UNITED STATES PATENT AND TRADEMARK OFFICE

Office Action Summary

10/037,525

DETAILED ACTION

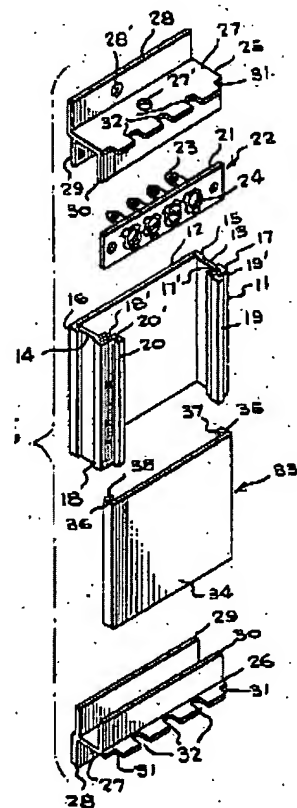
21. Regarding claim 4, a first flange 19 extends outwardly from the top surface of the top member 13 of said first member 11.

22. Regarding claim 5, a second flange 20 extends outwardly from the bottom surface of the bottom member 14 of said first member 11.

23. Regarding claim 6, said first flange 19 is generally perpendicular to the top surface of the top member 13 and generally parallel to the base.

24. Regarding claim 7, said second flange 20 is generally perpendicular to the bottom surface of the bottom member 14 and generally parallel to the base.

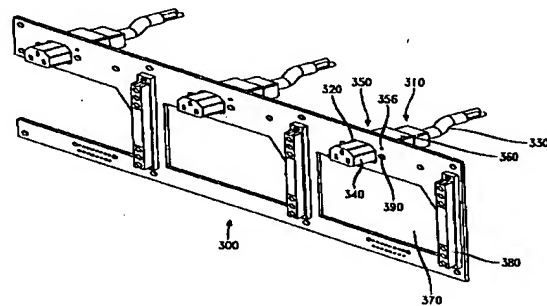
46. **Claims 24-27 are rejected under 35 U.S.C. 103(a) as being unpatentable over Mattingly as applied to claim 1 above, and further in view of Nguyen et al. (U.S. Patent 6,411,526).**

47. Regarding claims 24-27, Mattingly does not expressly disclose said face plate to be generally rectangular in shape with a top edge, a bottom edge and a pair of side edges; wherein the face plate is provided with one or more openings that correspond to openings in the modules; wherein the openings are preferably rectangular in shape, having two long sides and two short sides; wherein there are first and second orifices on said face plate that correspond to orifices in said module for receiving a connecting means for connecting the module to the face plate.

48. Nguyen et al. discloses a face plate 300 for linking a plurality of modules together, the face plate is provided with one or more openings 320 that correspond to openings in a module 310, wherein the openings are substantially rectangular in shape, having two long sides and two short sides, and wherein there are first and second orifices 390 on said face plate that correspond to orifices on the module 310 for receiving connecting means for connecting the module to the face plate 300.

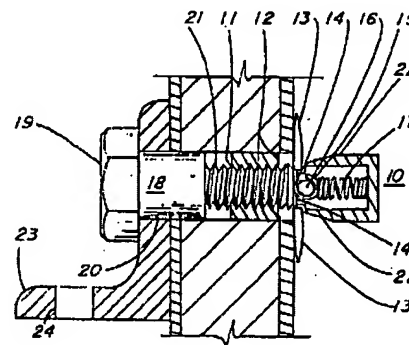
52. **Claims 28-29 are rejected under 35 U.S.C. 103(a) as being unpatentable over Mattingly in view of Nguyen et al. as applied to claim 27 above, and further in view of Johnson (U.S. Patent 4,764,065).**

53. Regarding claims 28-29, neither Mattingly nor Nguyen et al. discloses the module is connected to the face plate by a fastener comprising a pin having a head and a stem, said stem passing through the center of a ring, said ring having two or more wings extending from the underside of the ring, wherein when said head is in a raised position the pin and the wings may pass through the orifices of the face plate and the module, and wherein once the pin and wings

54. Johnson discloses a pin 18 having a head 19 and a stem 20, said stem passing through the center of a ring 10, said ring having two or more wings 13 extending from the underside of the ring, wherein when said head is in a raised position the pin and the wings may pass through the orifices of the face plate and the module, and wherein once the pin and wings are through the orifices, a downward motion on the head of the pin causes the stem to expand wings thus causing the two face plate and the module to be secured together or wherein raising the pin will cause the wings to retract thus permitting removal to the fastening means from the orifices in said face plate and said module.
